## **Responses to the June 2002 PAC Recommendations**

The DØ Collaboration  
August 8, 2002

Figure 1. A comparison of the CFT occupancy by layer (the order is XUXV...) for minimum bias events in collider data and those generated by the Pythia Monte Carlo.

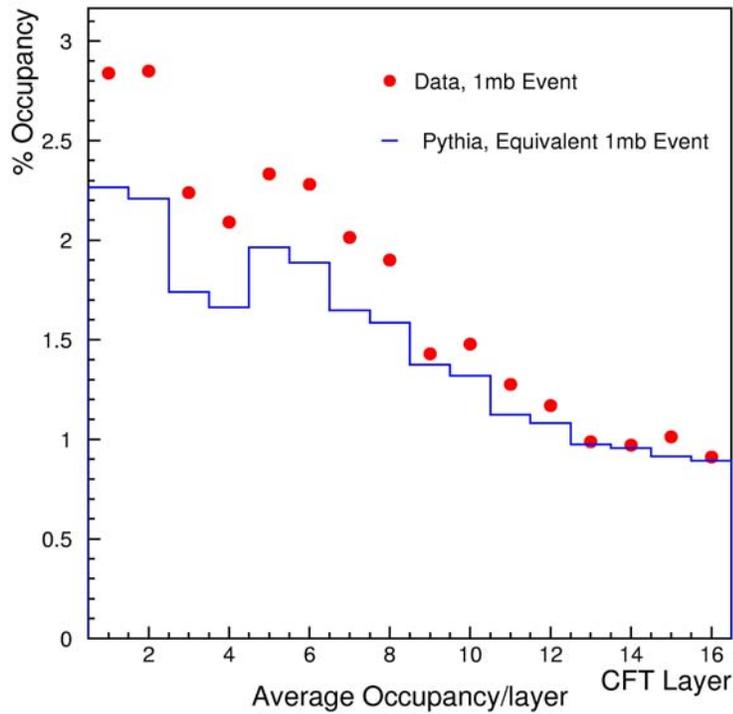
- **How does the performance of the existing tracking triggers and the proposed tracking triggers compare to the requirements, as a function of the number of multiple interactions per crossing? How well do simulated occupancies compare with data?**

We share the concern of the committee that one of the big uncertainties in the tracking trigger upgrade is how much faith one can have in the simulations at high occupancy. We have therefore directed our major effort since the last review not at new simulations, but at understanding the occupancy in minimum bias events in Run II data and comparing against our simulation.

While the L1 track trigger for Run I is still being commissioned, the fiber tracker electronics has begun to function at close to the expected signal-to-noise performance. This makes the occupancy meaningful. We have therefore been able to compare the occupancy observed in data (minimum bias events after noise subtraction) with that in the simulations we have been using (PYTHIA). The results are shown in Fig. 1. The discrepancy at low radii may indicate a material modelling shortfall in the simulation and we are investigating this. Overall the agreement is quite good.
